# ADDENDUM PURCHASING OFFICE CITY OF AUSTIN, TEXAS

Solicitation: RFP 8100 ELF3010 Addendum No: 4 Date of Addendum: 04/30/2020

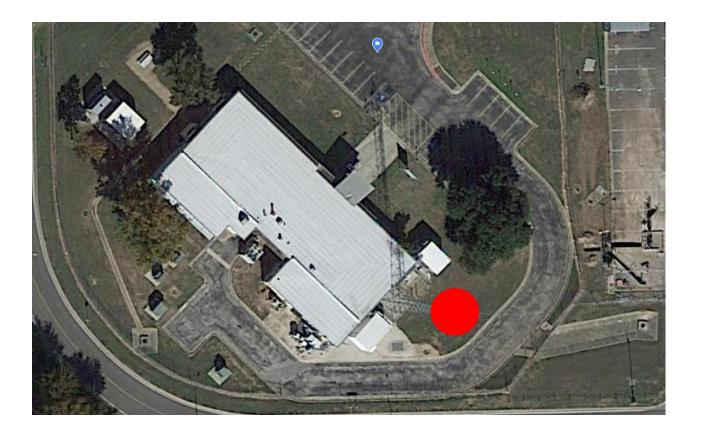
We cannot conduct a site visit at this time due to COVID19 restrictions and the active construction site conditions at the IT building.

Attached is a Google Earth image of the site that may be used to estimate cable lengths. Satellites would sit in the area of the red dot and connect back into the building near the cell tower. Distance inside the building to the equipment would be 50 - 70 feet. The address of the building is 3011 Employee Ave. We ask that vendors provide a "best guess" estimate.
